Plan Commission Meeting Agenda

TOWER DRIVE CONDOMINIUMS PHASE 1
SECTION 14, TOWNSHIP 10N, RANGE 12E

Ruekert & Mielke, Inc. has completed our review of the site plan for the above referenced project, with an application date of July 15, 2026. The submittal was reviewed in accordance with Columbus Ordinance Chapter 90 - Subdivision and Chapter 114 - Zoning, Chapter 47 - Erosion Control and Chapter 48 - Storm Water Management. This review does not constitute a recommendation for future phases. Future phases for development on this lot shall require additional review and approval. This review may not include all City requirements for this submittal. We offer the following comments, clarifications, or concerns:

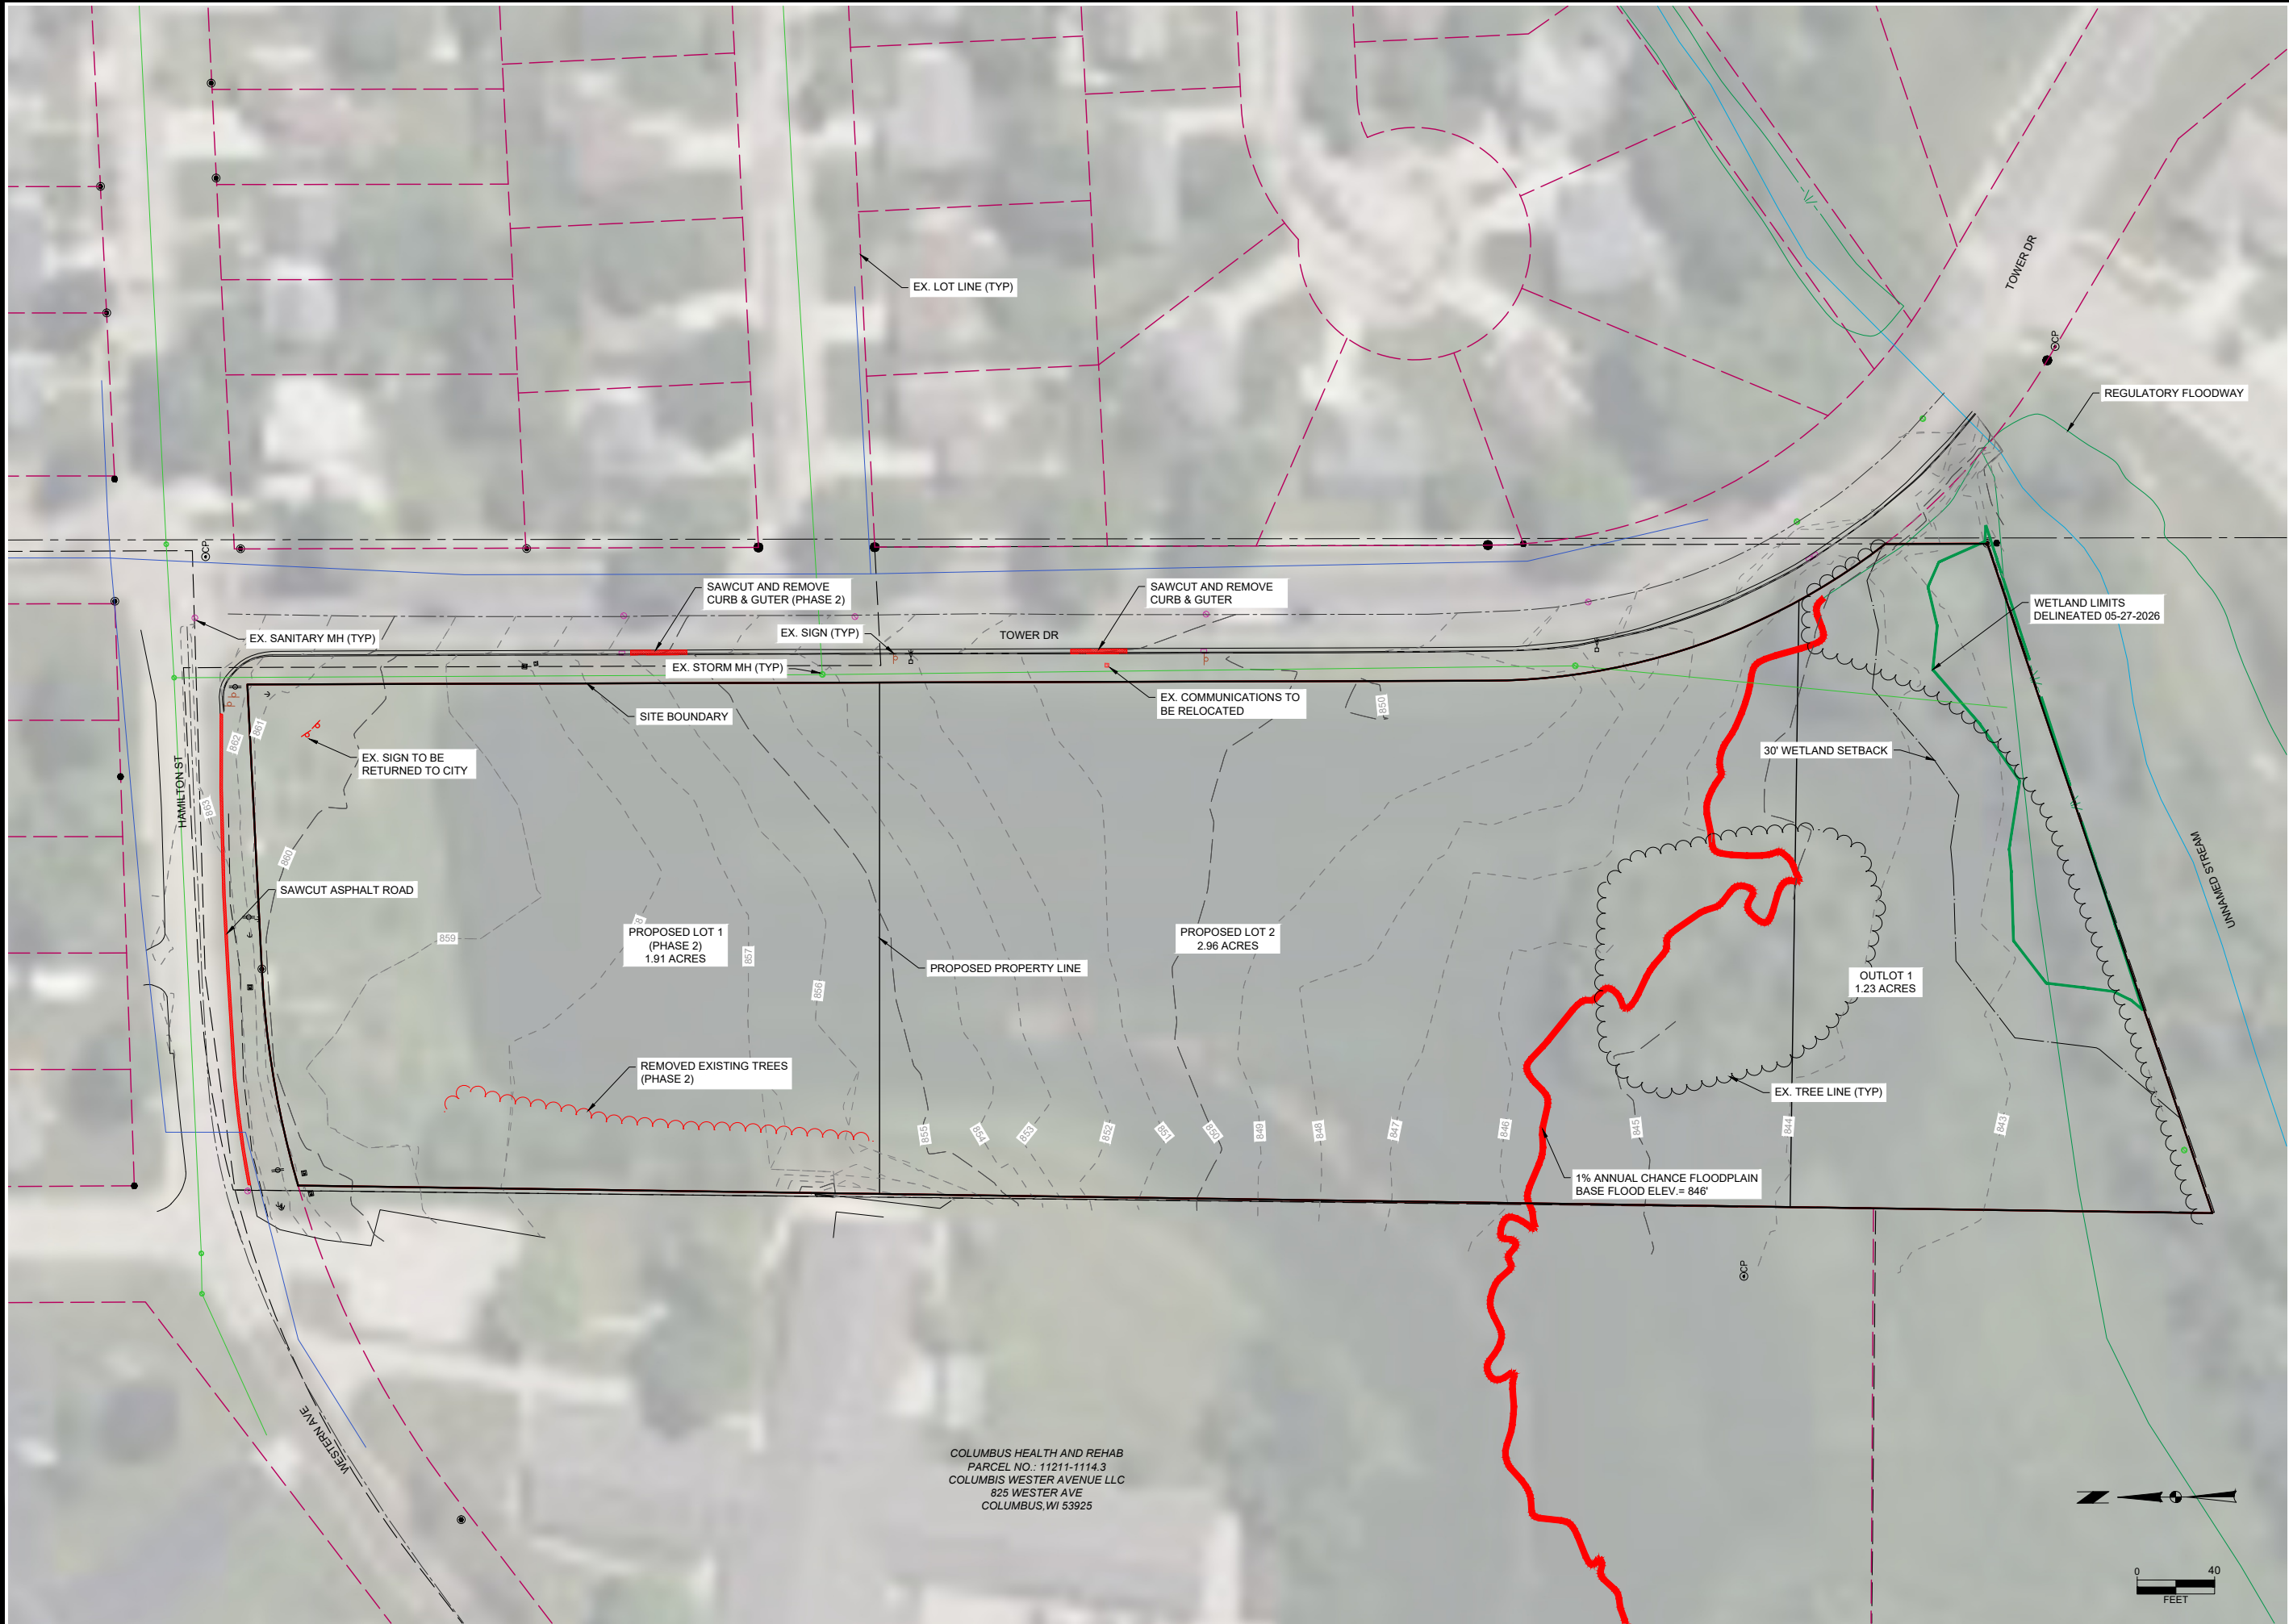
1. There is an existing curb opening across from Meadow Lane. Please show it as being removed and replaced with full head curb if it is not used.

GRADING PLAN

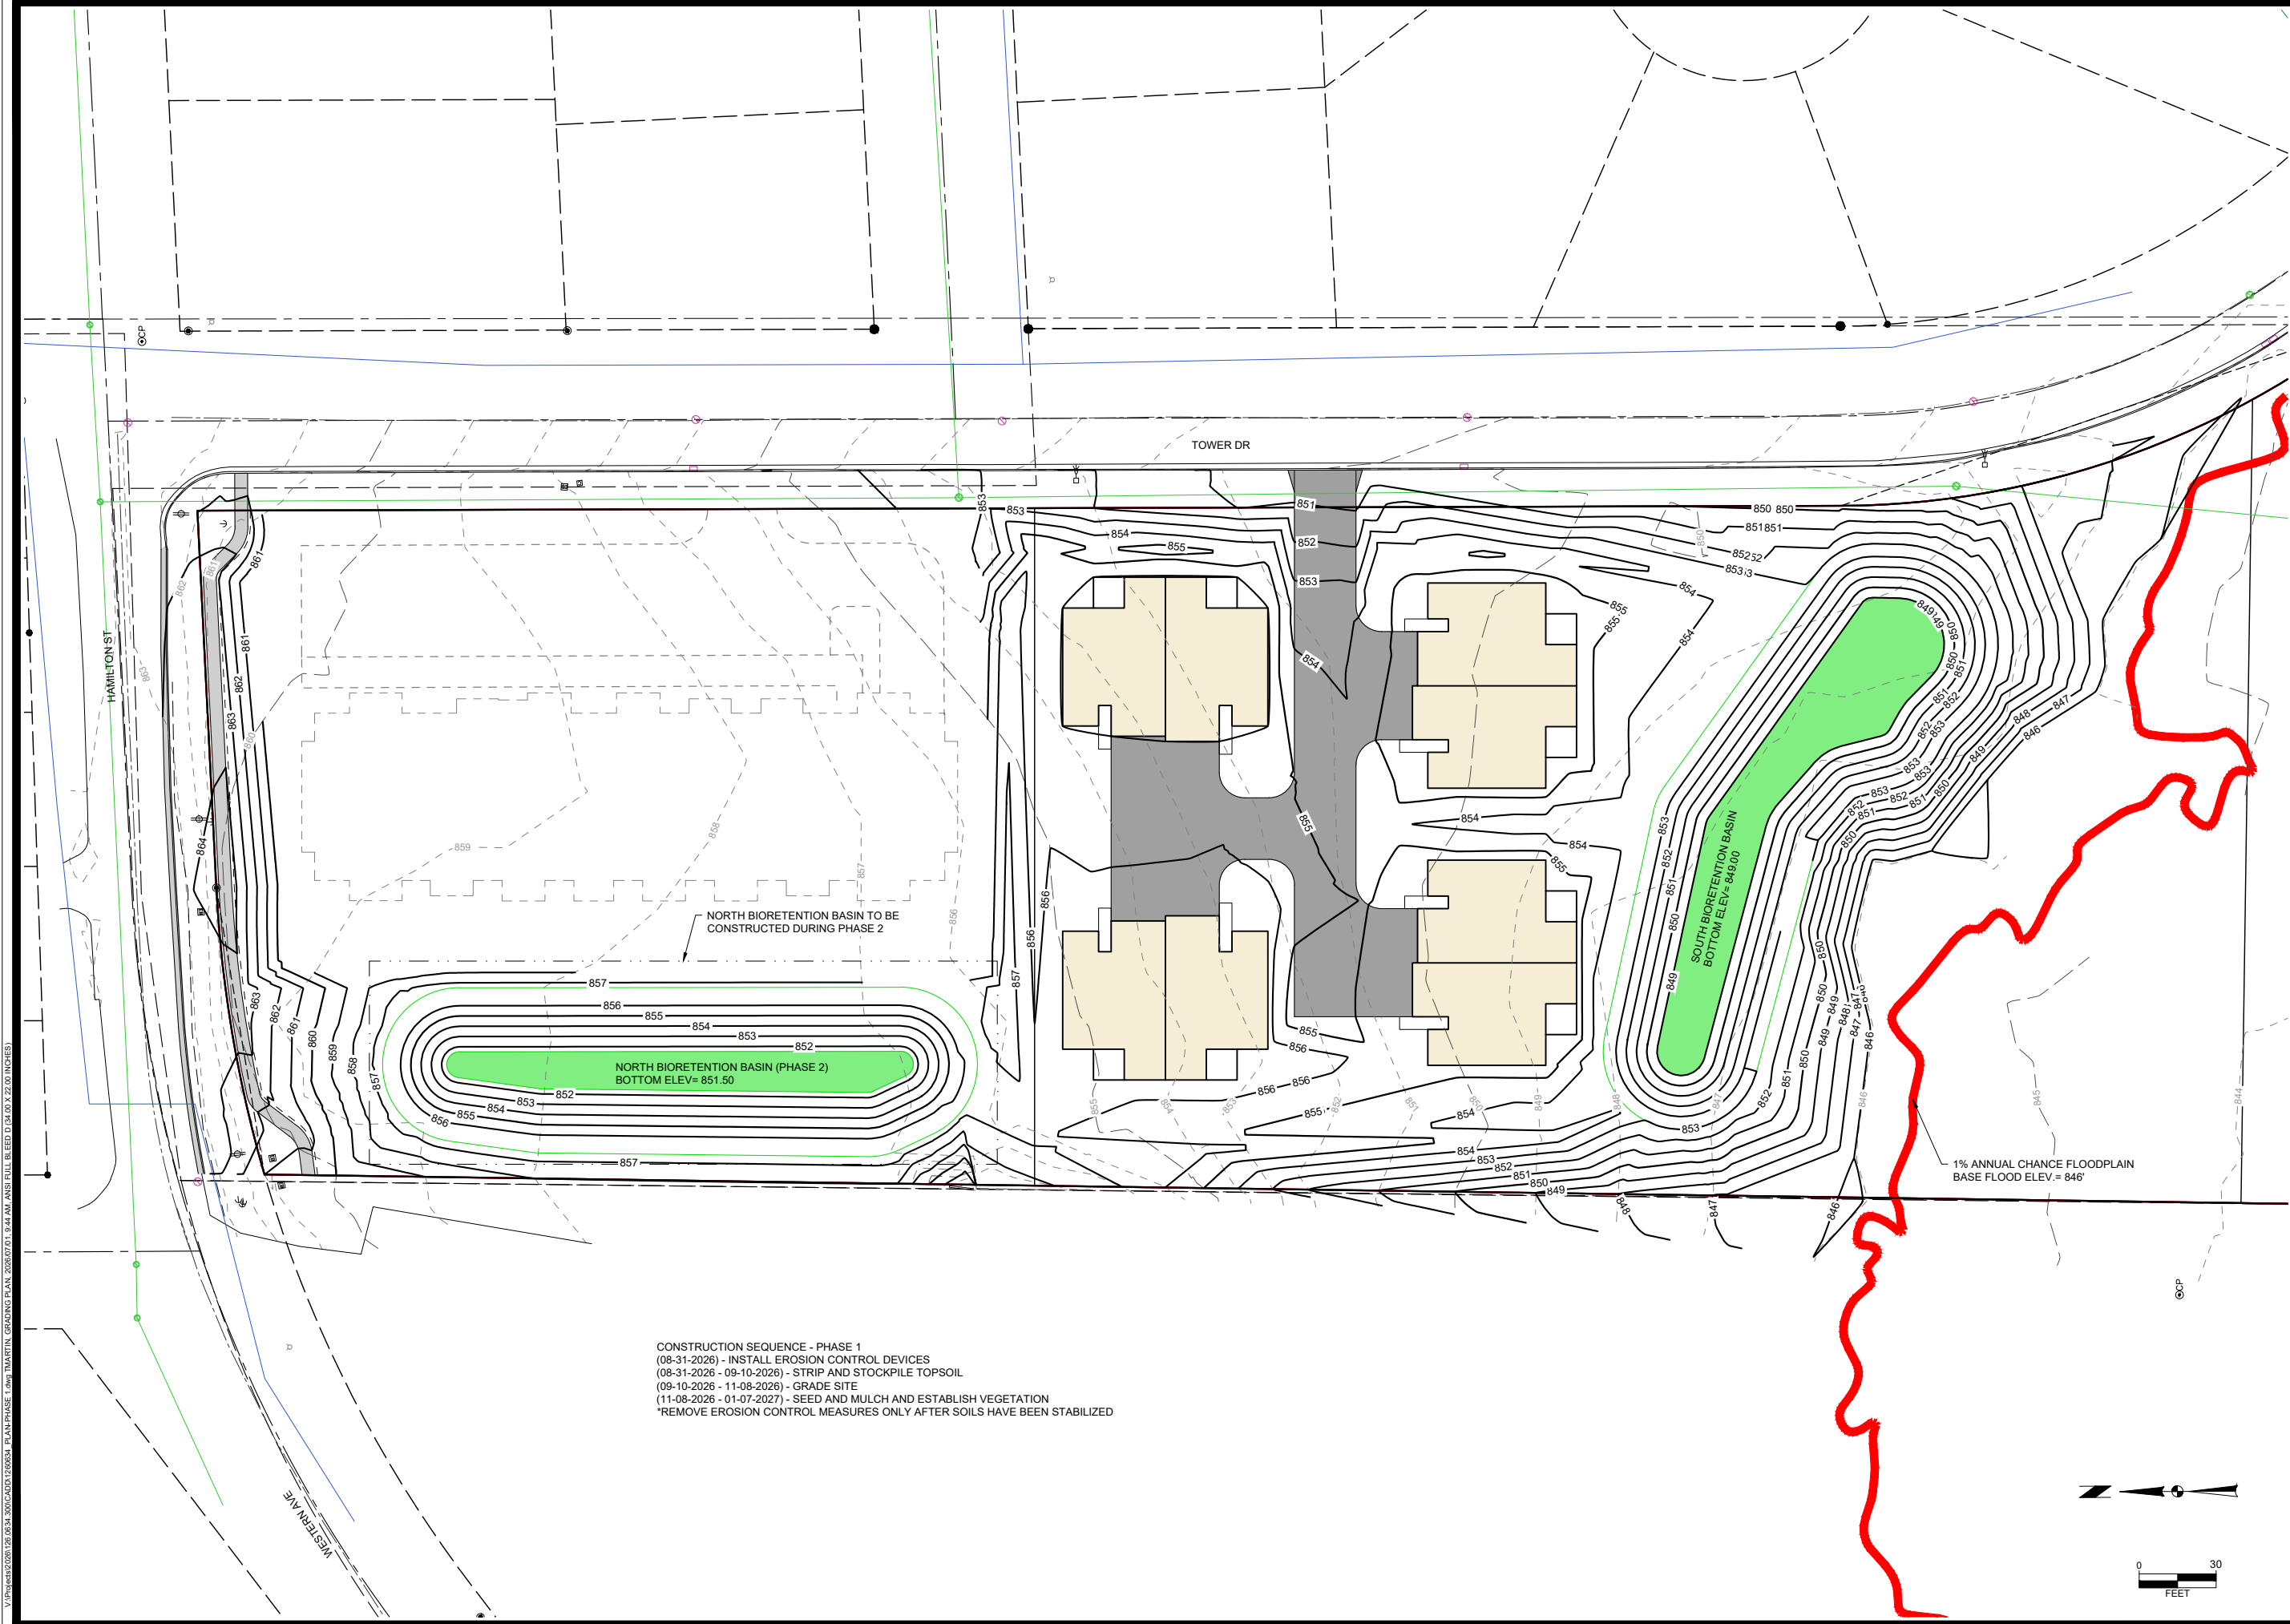
1. Please revise grading/contours so that all grading activity is within property limits.
2. Add inlet protection to both sides of Tower Drive.
3. Adjust silt fence to be within property limits.
4. Show construction entrances and tracking pad locations on plans.
5. Show the location and detail of a concrete washout area on the plans.
